Appellants Statement

Machine Shop, LLC is appealing the following conditions of approval for the building's Historic Variances and Certificate of Appropriateness, approved on August 19, 2014:

NORTH AND WEST EXTERIOR ELEVATIONS - EXISTING
MACHINE SHOP
FOR SCHAEFER RICHARDSON, INC.
334 2ND STREET S.E.
MINNEAPOLIS, MN 55414

A4.2

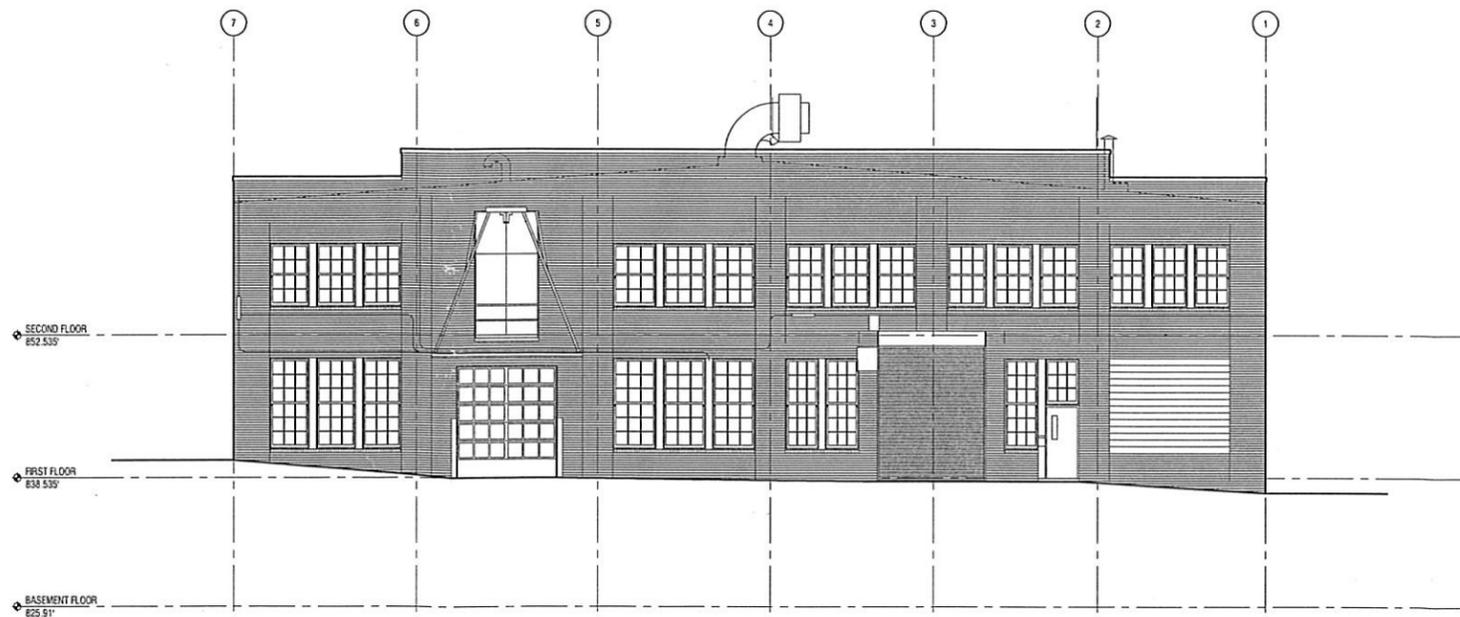
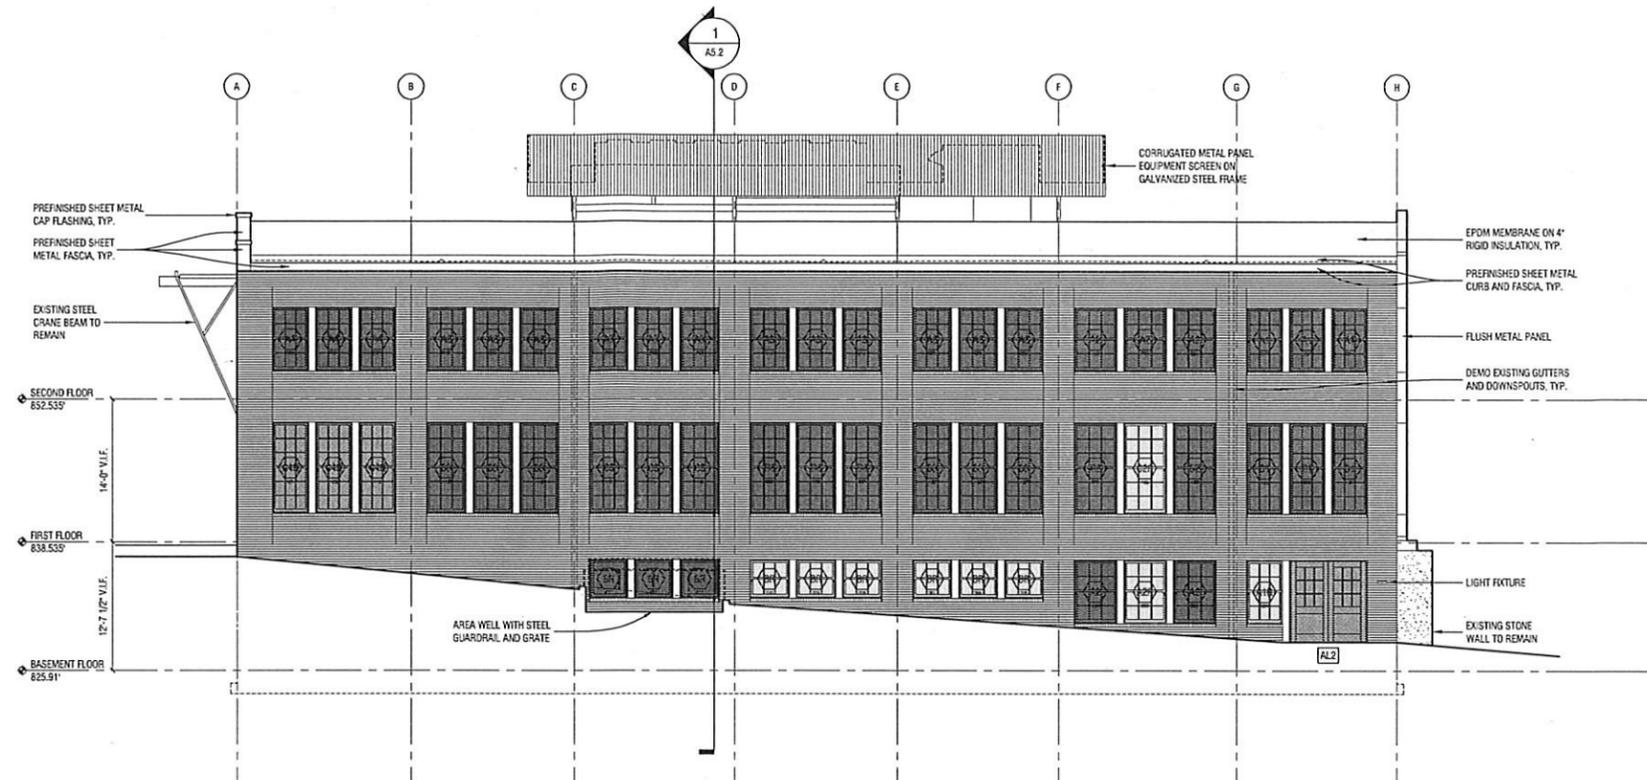
Condition #5: The existing second-story cargo door is a non-historic addition ca. 1960s to accommodate an overhead crane and interior track used to move materials in and out of the building. The 1960s installation of the cargo door removed three, wood, double-hung windows and surrounding brick. The current cargo door is a two-panel, hollow metal with a metal double-door transom. The door system is uninsulated and non-weather tight; there is frost built up at the door and releasing heat in the winter as well as allowing rain water to enter the building. Because the opening and door are not original and difficult to weatherize without also damaging the existing brick surrounding, we have proposed to replace the cargo door assembly with aluminum doors and wood transom. The two-panel doors would be operable but, at that upper level, there is no need for pedestrian egress. The new door assembly would be weather-tight but, in the open position, would allow light and air circulation into the second story mezzanine level. The existing horizontal metal bars in the opening, which would prevent someone from stepping or falling out through the opening will be retained.

The proposed door schedule is shown on A8.1 and detail on A7.6. See A4.2 for the existing exterior elevation and A4.4 for the proposed exterior elevation.

Condition #13: The three new windows proposed at the basement level, west elevation are proposed for additional light and reuse/rent of interior space (see A4.2 for the existing exterior elevation and A4.4 for the proposed exterior elevation). The new window openings propose wood sash to match the existing historic basement windows, but there will not be divided lights so as to differentiate the new windows from the existing windows (the window schedule is shown on A8.2 and detail on A7.5). The removal of window muntins at the new windows was per the request of the SHPO/NPS, which approved the new opening. An area well with steel guardrail and grate is proposed at this new bay of windows, encroaching into the sidewalk by only two feet. The covered area well below grade is one foot deep and increases to three feet deep, south to north, due to the slope of the sidewalk. In addition, the owner has received approval for the encroachment permit from the Minneapolis Department of Public Works Right of Way Section.
